The Honorable
Jane Hague and Kathy Lambert
King County Council
Seattle WA

Sept. 27, 2010

RE: Sammamish River Weir Visit

Southwest Channel Following Trimming (From Atop Weir)

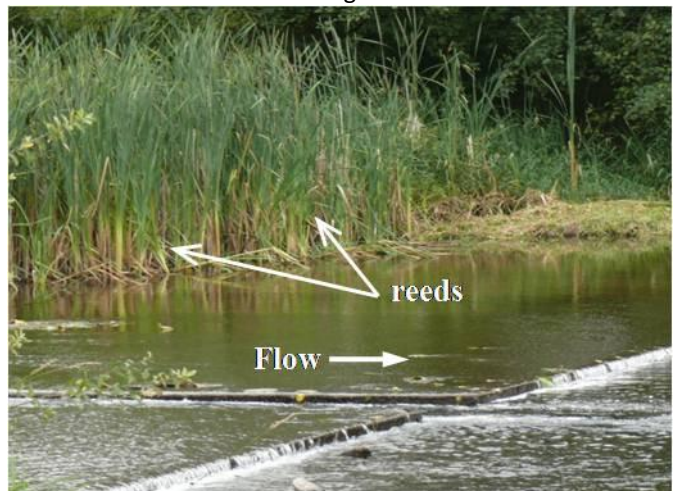
Observations - The southwest (left) channel of the Transition Zone, which flanks the low-flow center channel, was brushed (i.e., trimmed) in late August. However, during our site visit, one of the County technical staff noted that, in the past, flow data showed no discernable improvement following brushing of the left channel. This seems logical, given the accumulation of 12 to 18 inches of debris and sediment which has built-up above the quarry spall riverbed, raising the left channel elevation to a level well above that of the weir. This build-up of clippings and sediment explains why past brushing of the left channel

showed no flow improvement; the channel's sediment build-up is acting like a riverbank rather than a riverbed, constricting and funneling the flow towards the center channel rather than allowing water to spread-out over the full width of the left channel.

- 1) The cuttings, which were allowed to remain after brushing, should be removed as soon as possible while water levels are relatively low.
- 2) Accumulated debris, clippings (duff), and sediment need to be removed down to the quarry spall riverbed base in order to return the channel to its original design condition. Failure to remove this build-up will merely perpetuate the ongoing ineffectiveness of most of the Transition Zone area by restricting water outflow leading to high water levels in the lake, property loss, and unnecessary pollution (see photos in Appendix A).

1993 Brushed Northeast Channel

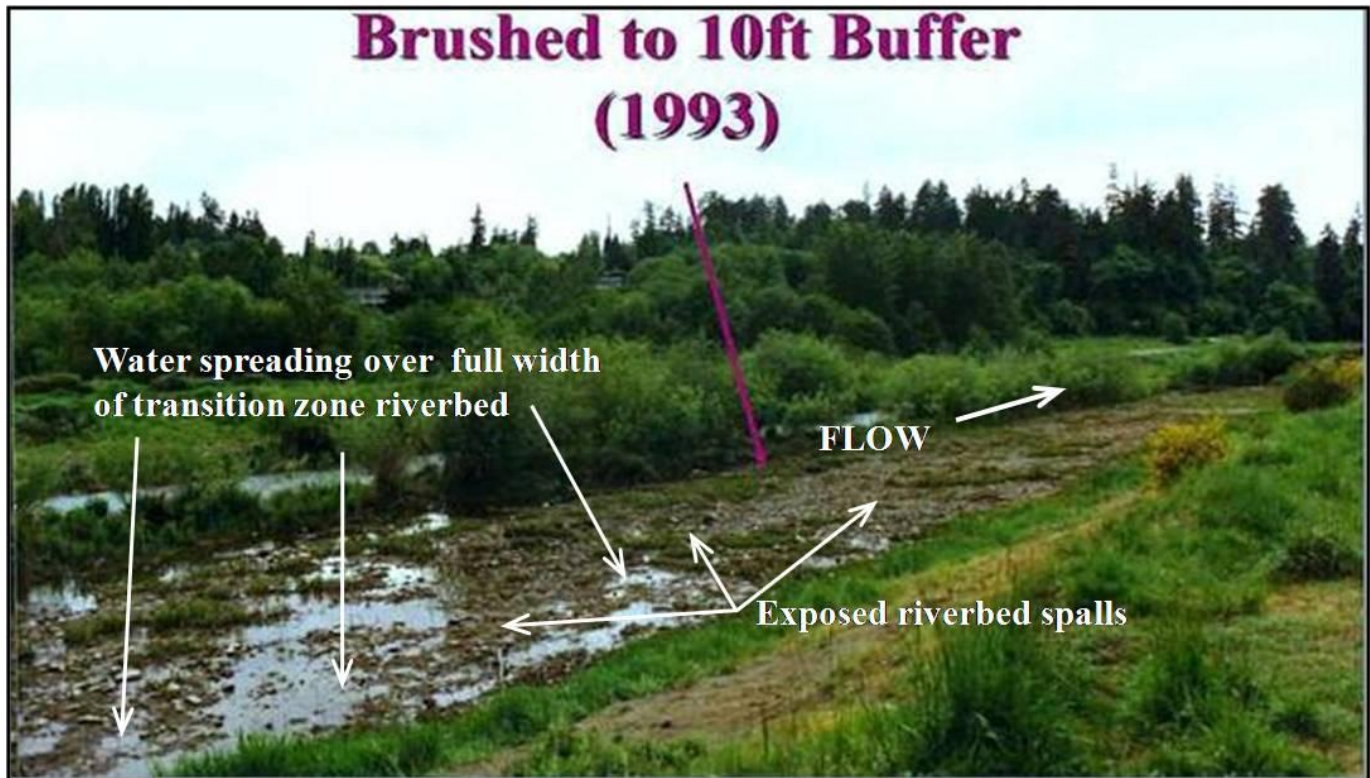
As you may recall, during the site visit I handed-out a 1993 picture of the post-brushing condition of the northeast (right) channel for attendees to compare against the conditions we were observing that day. Most noticeable from the 1993 picture were: 1) the willows were cut to a to a hedge-like edge, 2) the center channel was open and freely flowing in the background, 3) the northeast channel's quarry spalls were exposed (not covered in sediment), and 4) water is spreading and seeping over the full width of the recently cleared channel. The 1993 picture (included below) showed what the TZ condition ought to have looked like in the cleared, left channel during our visit on September 9. I think everyone who attended would agree, what we saw was not reflective of the 1993 brushed condition.

Several citizens also commented on the narrowing (necking) effect the vegetation appeared to have along the Sammamish River banks upstream of our location. Most noticeable of this physical narrowing of the upstream river channel were the reeds growing immediately ahead of the weir. This obstruction can be seen in the picture above. Upstream constraints will restrict flow during high water conditions.

- 3) The reeds ahead of the weir, as well as other vegetative restrictions along the river banks, all the way back to the lake, which are reducing the effective width of the upstream river channel, should be planned for removal next season.

Aerial Photo Showing May 2010 Flow Conditions

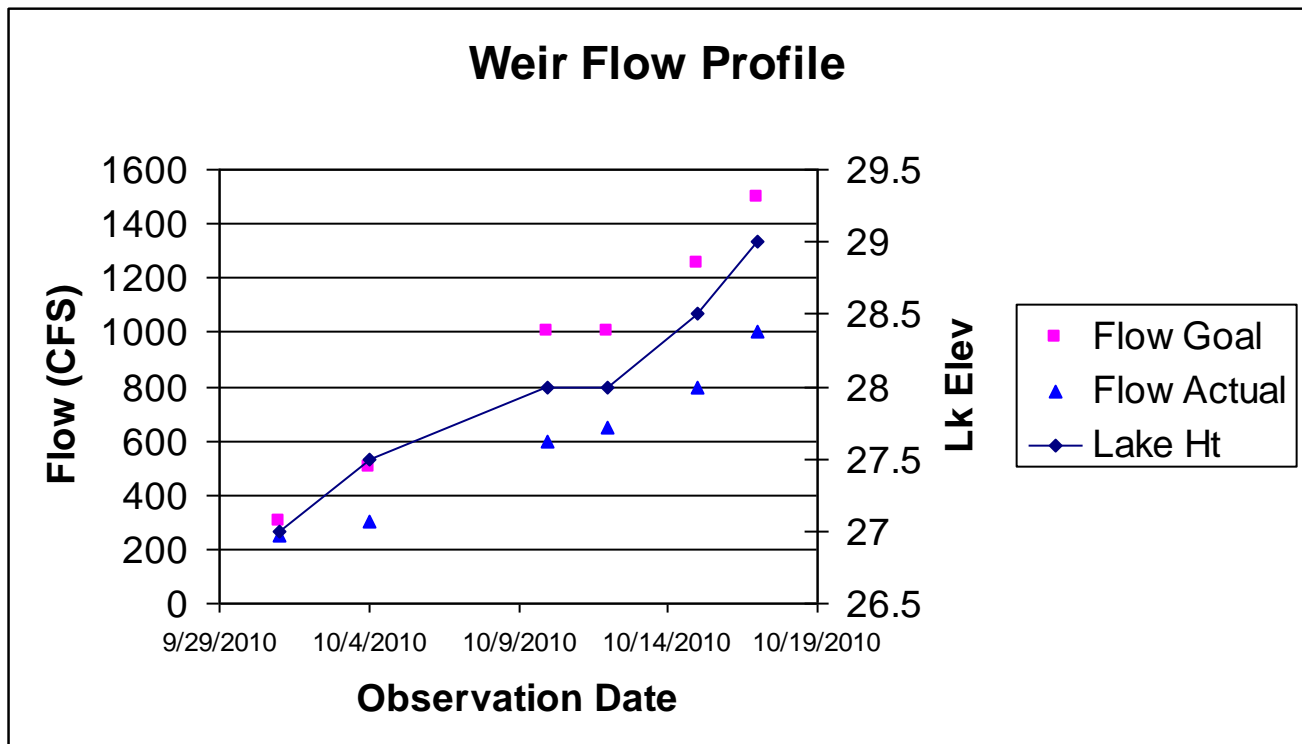
Second, free flowing water can be seen downstream of the transition zone (see left photo above) and in the middle of the TZ last spring (see photo below). Constricted, “slack” flow would indicate a backup caused by a downstream blockage or impedance, which is not evident at these two locations. There is no evidence that Bear Creek is or was, in anyway, affecting water flow out of Lake Sammamish this past spring. However, slack flow was witnessed at the weir during the late spring high water event, indicating that the immediate downstream conditions (the willows and blocked channels) were indeed restricting the free flow (see photo below).

- 1) Computer Analysis Precision - Accurately identifying the variables and assumptions in the computer model(s) will lead to more accurate results. If the models did not predict this spring's high waters, they need to be recalibrated. Second, wide ranging patterns of plant growth and debris accumulation will impact these models. Consistency of channel maintenance is key, as intended by the Operation and Maintenance Manual. This would allow staff hydrologists to employ realistic, but limited roughness coefficients in the model, resulting in much more accurate computer modeling of flow conveyance and flood potential. With variables reduced, the computer models then can readily be calibrated against actual stream gage data.

Shrub & Tree Overgrowth Below TZ Affecting Downstream Flow

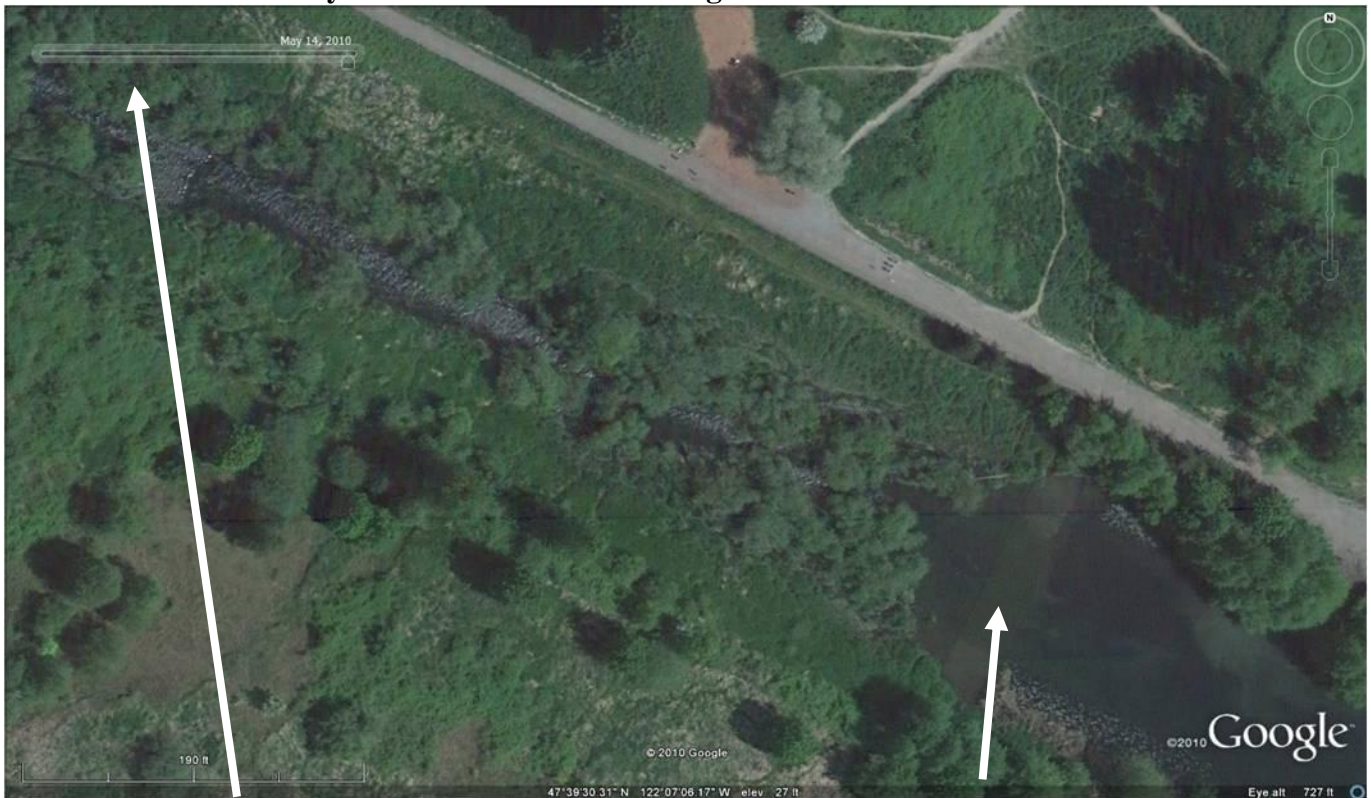
If there's some possibility that Bear Creek is involved, are there actions which would mitigate that? The major factor with flows from the weir to Bear Creek is the roughness along the banks. Extensive brushing of the channel from the transition zone to Bear Creek along both sides would help to reduce backwater effects if there are any. You can see this is needed in your photo from May. A great deal of brushing could be done at the end of the transition zone toward Bear Creek.

One other observation we'd like to note, to see if you concur. In the photo inserted below, from May 2010, when we know high flows were occurring, it appears that conditions have changed over time in another way. All flows seem to funnel toward the low flow channel, even at the north end of the of the transition zone heading toward Bear Creek. Is it not also important to assure the side channels are cleared all the way to that point, or is that what you were suggesting the clearing was for, toward Bear Creek, above?
